Field No. SO-1150 ..... Office No. H-7878

Locality OLD TAMPA BAY, NORTH OF COURTNEY

REVIEW OF HYDROGRAPHIC SURVEY

Florida, Old Tampa Bay, North of Courtney Campbell Causeway

H-7878  
Jo fit

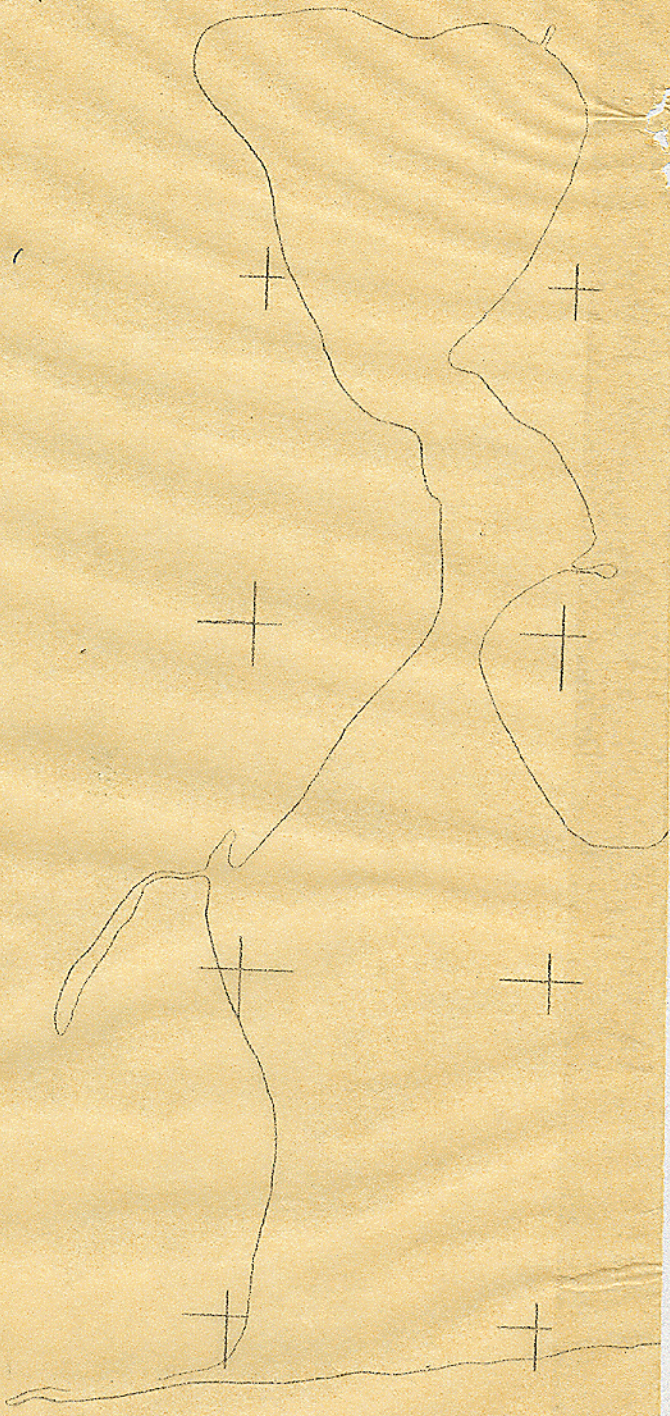
587  
3-ft

curve  
now 61  
HN  
38'
